SHERMAN, ILLINOIS
ANDREW ROAD
M.P. 177.87
SPRINGFIELD SUBDIVISION
D.O.T.#294 281X

THE ONLY CHANGE TO THIS LOCATION IS ON SHEET 1. ALL OTHER SHEETS ARE FOR REFERENCE ONLY.

Designed: 08/21/12
TIER 3 PHASE 3
M.P.177.00 TO M.P.160.00
UPGRADE XINGS AND CP'S FOR HIGH SPEED RAIL
Rec#: WO#: 22820
IS: /MWK /NST/MJF

| Date: 04/01/02 | UNION PACIFIC RAILROAD | Sh.: 1 | |

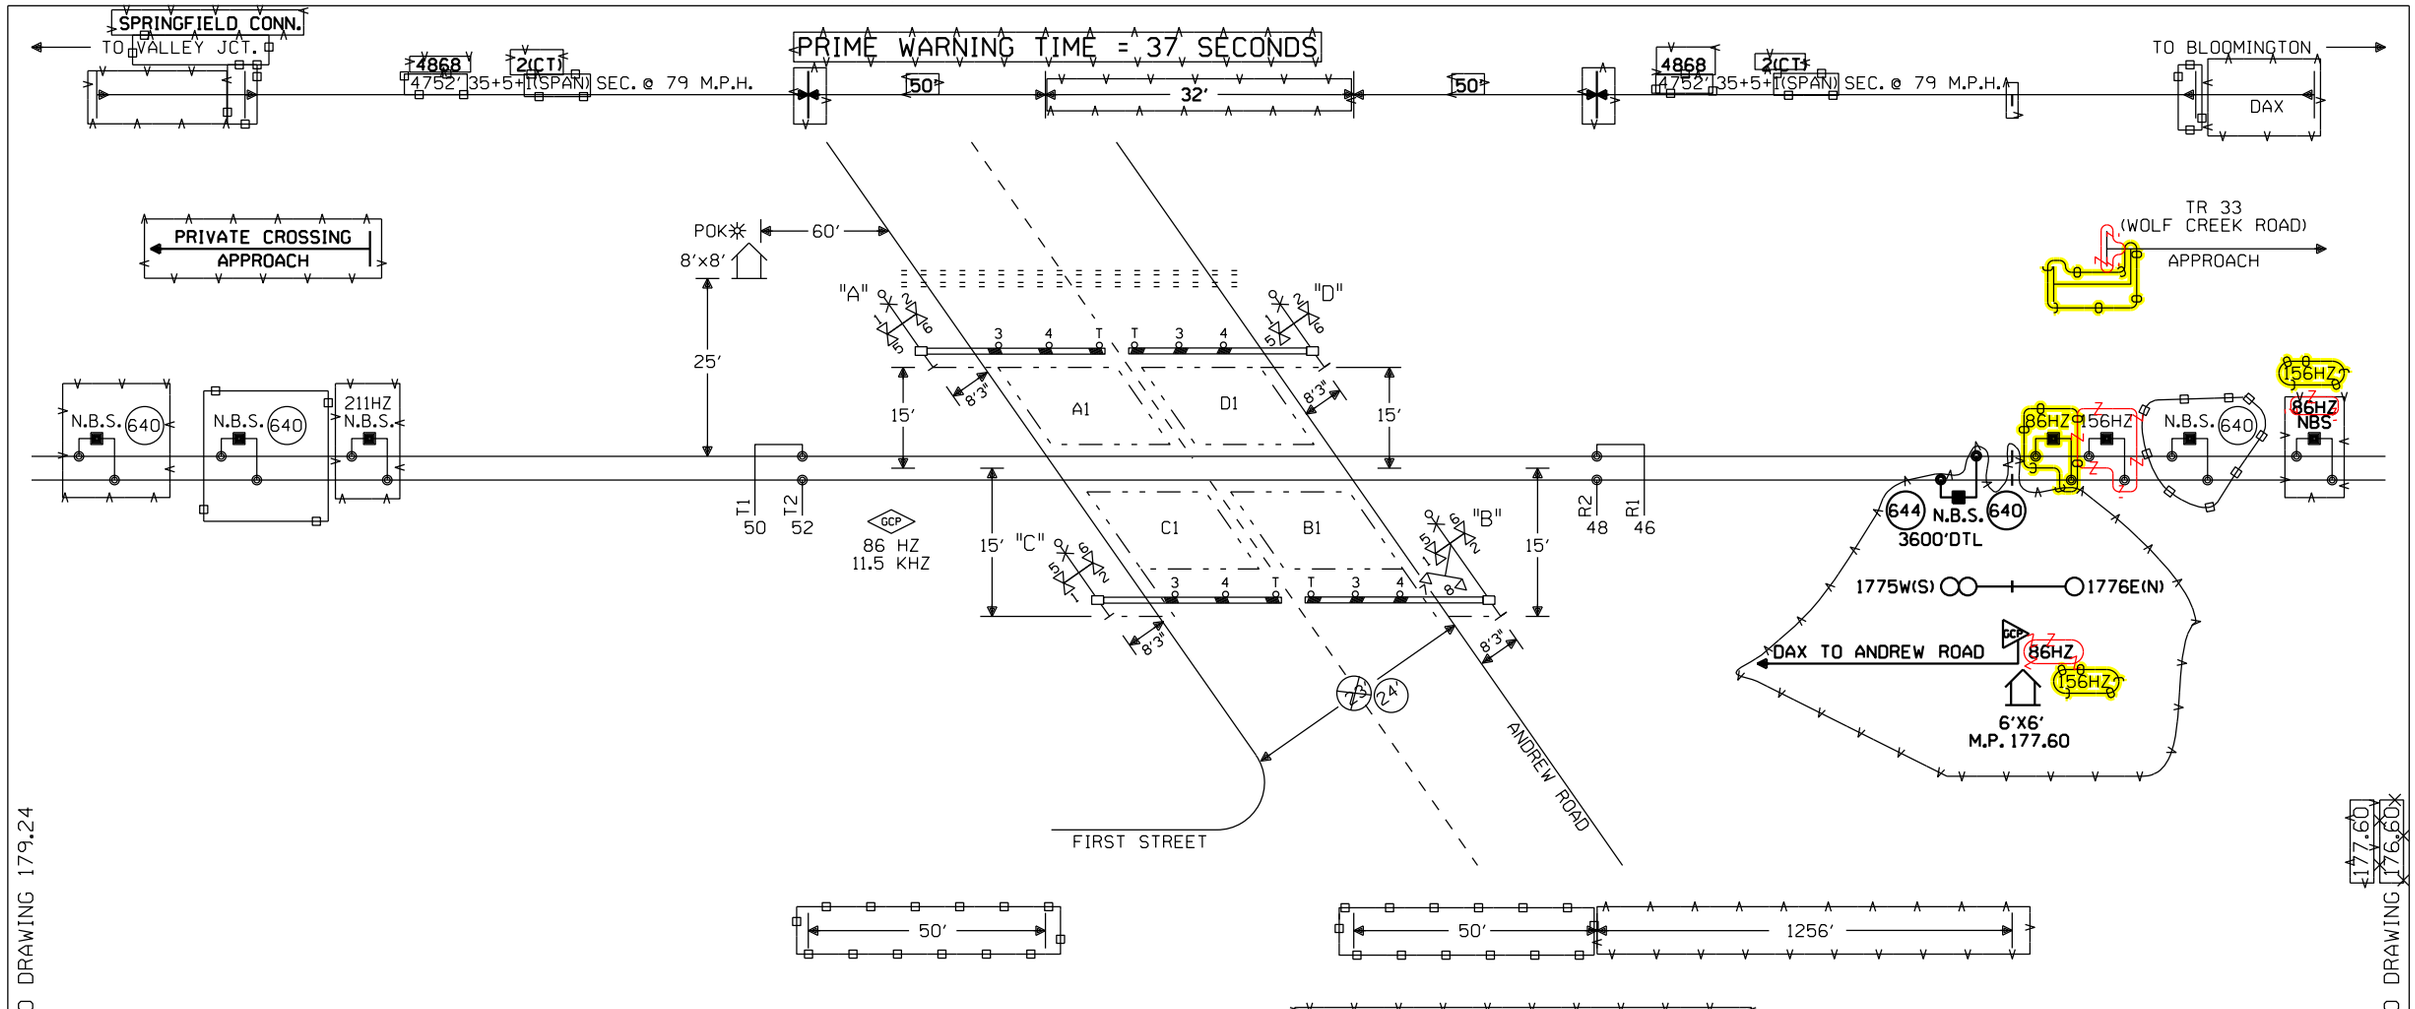
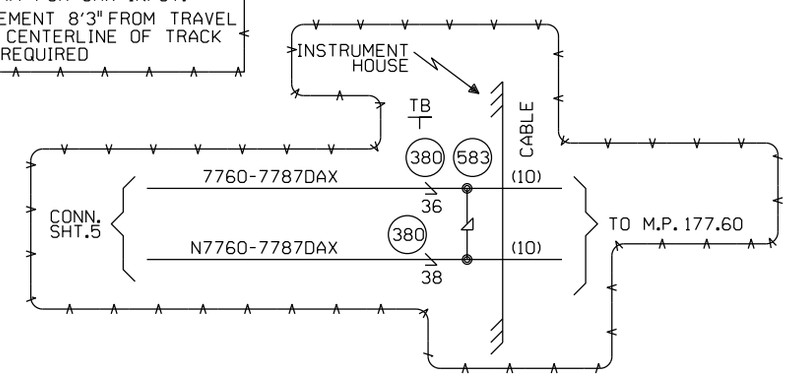
1. MODIFY GCP PROGRAM FOR UAX INPUT.
2. VERIFY GATE PLACEMENT 8'3" FROM TRAVEL WAY AND 15' FROM CENTERLINE OF TRACK AND RELOCATE IF REQUIRED
